**TOWN OF NEWBURGH
PLANNING BOARD
TECHNICAL REVIEW COMMENTS**

PROJECT: SERVISS SUBDIVISION
PROJECT NO.: 19-10
PROJECT LOCATION: SECTION 34, BLOCK 1, LOT 25.2
REVIEW DATE: 18 JUNE 2019
MEETING DATE: 20 JUNE 2019
PROJECT REPRESENTATIVE: JAMES A. DILLIN, PLS/TALCOTT ENGINEERING

RE: Serviss
2019-10
Section 34 Block 1 Lot 25.2

SUBDIVISION OF PROPERTY
FOR

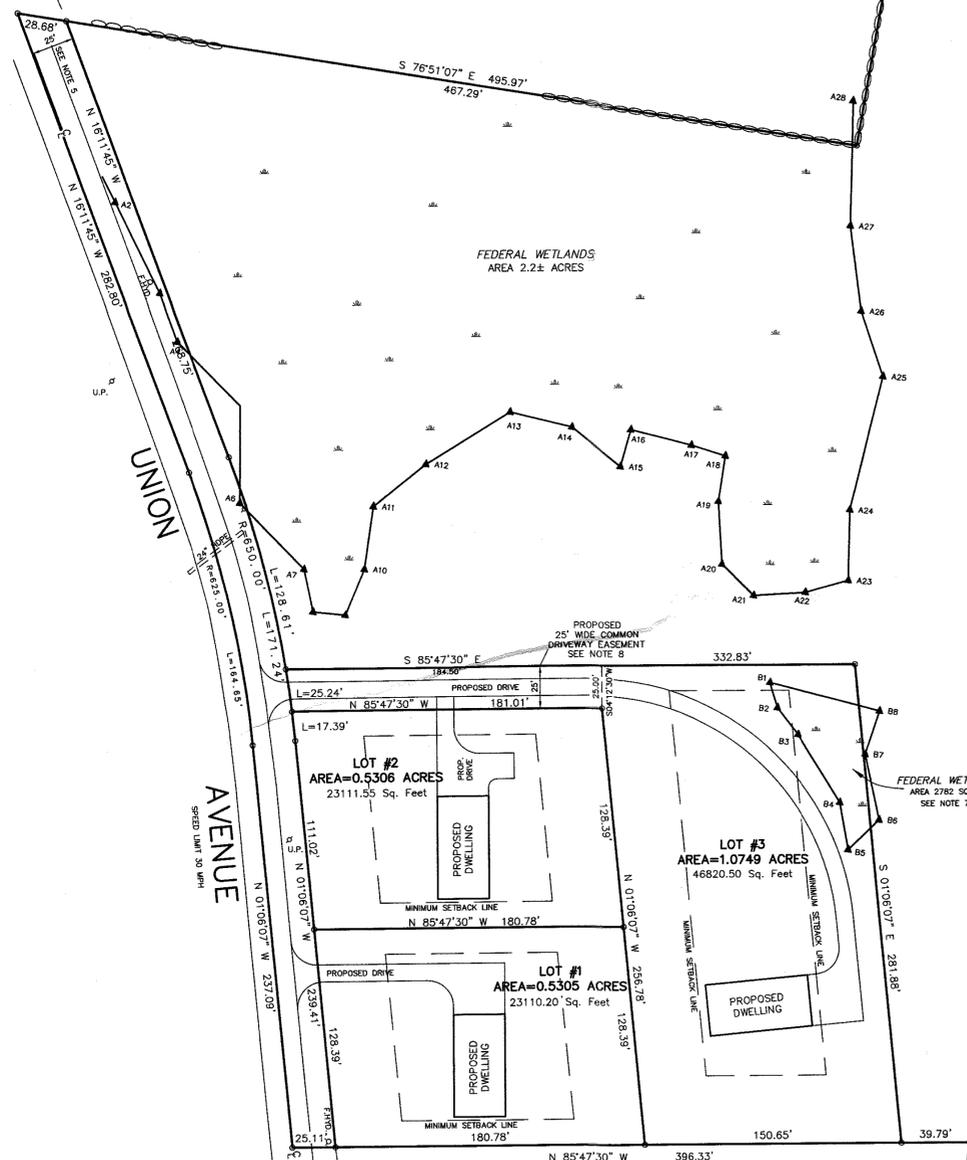
3. Note #4 on the map identifies that the wetlands were flagged on 2 July 2018 by Peter D. Torgeson. Note #7 has been added to the plans proposing to fill in wetlands to provide for separation distance to septic system

4. Previous comment #7 requested the Grading Plan and limits of disturbance be provided for the lots. The addition of the re-grading of the wetland areas will most likely cause greater than one acre disturbance on the project site and require coverage under the NYSDEC Stormwater SPDES program, a SWPPP for residential projects should be prepared.

6. Wetlands on Lot #3 are to be eliminated (see Note 7).
7. Grading Plan is shown on Sheet 2 of 4. Limits of disturbance and soil erosion and sediment control detail are shown on Sheet 4 of 4.

TYPICAL WATER SERVICE DETAIL

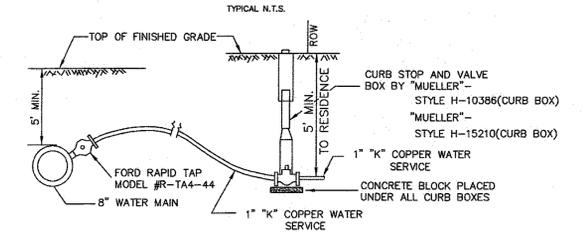
1. Comments from the Highway Superintendent should be received. Site distances have been added to the plans on Sheet 4 of 4.
2. One inch service laterals are provided on the plans. The Applicants representative is requested to coordinate the curb stop identified in the Town of Newburgh Water System notes versus the one identified on the detail.
